Product information

Battery Holder NL5077-LF

Product Change Notification	Reason for proposed change	Description of change
	☐ Customer requirement	Correction of tolerances and dimensions on drawing
	☐ Quality complaint Nr.	
	☐ Quality improvement	
	☐ Process improvement –	
	☐ technical modification	
	☐ Normative requirements	
	☐ Cost efficiency	
	☐ Second source	
	☒ Correction of the documents	
	☐ Production location, change	
	☐ see attachment

actual drawing 3.8756.4-1

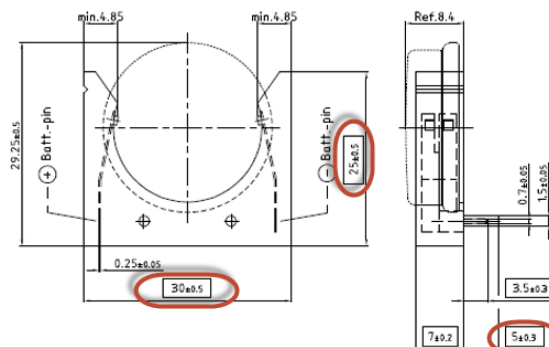
Adjustment of tolerances and pin dimension to current product.
Renata always produced and released battery holder per new adjusted drawing.

Concerned dimensions and tolerances are as below:
Marked dimensions & tolerances are adjusted

adjusted drawing 3.8755.4-2
according real production

Annex I: actual drawing (→becoming obsolete)

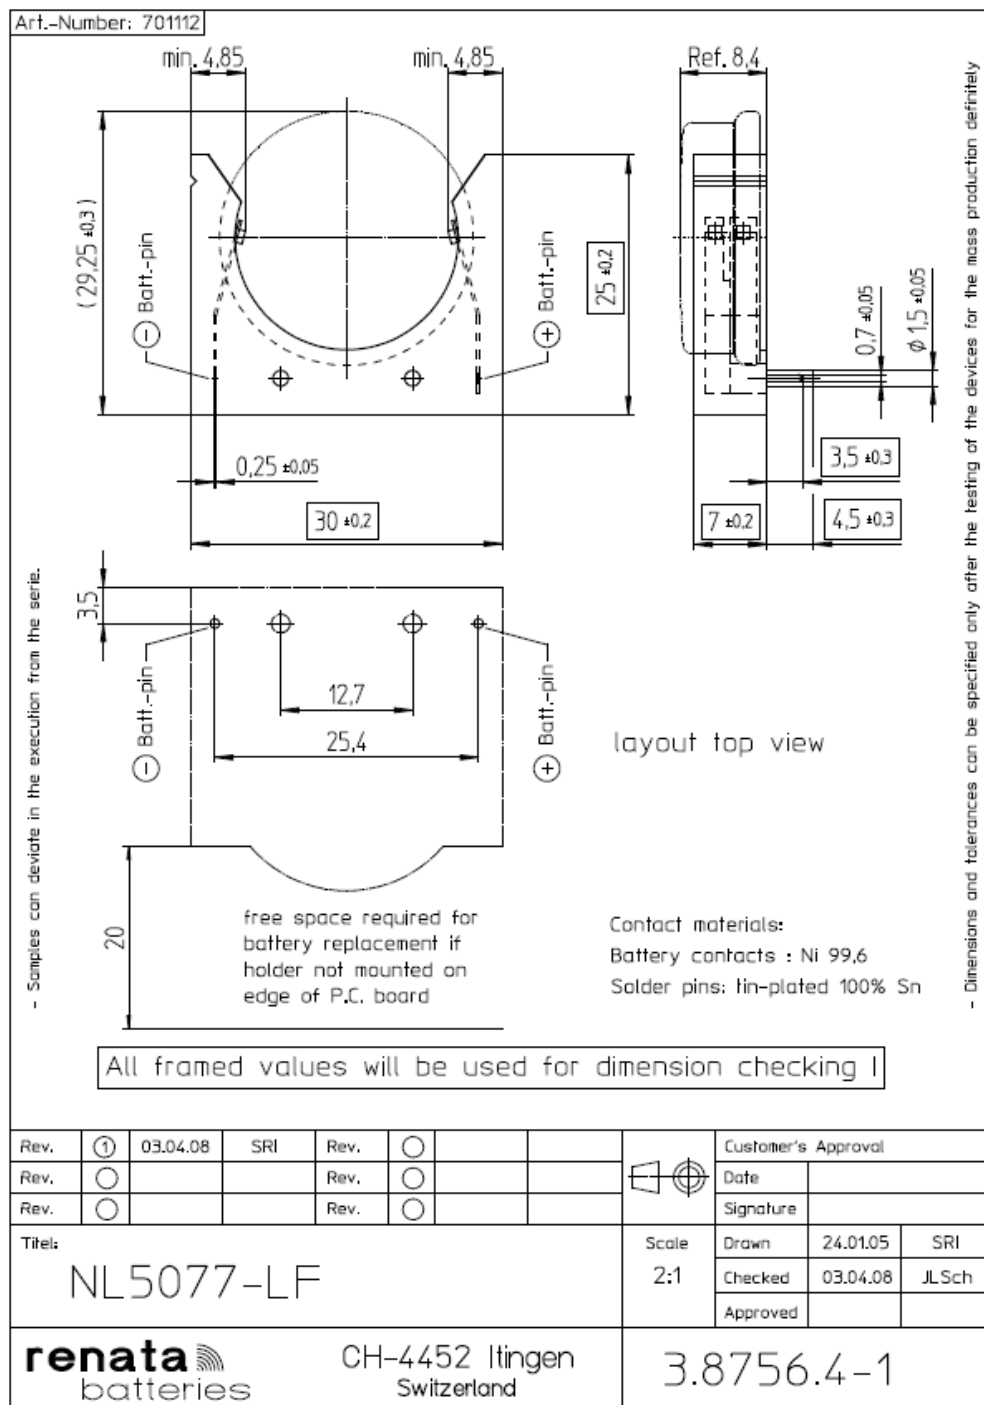
See Annex I and Annex II on following pages for full drawings.

Annex II: adjusted drawing (→immediately effective)
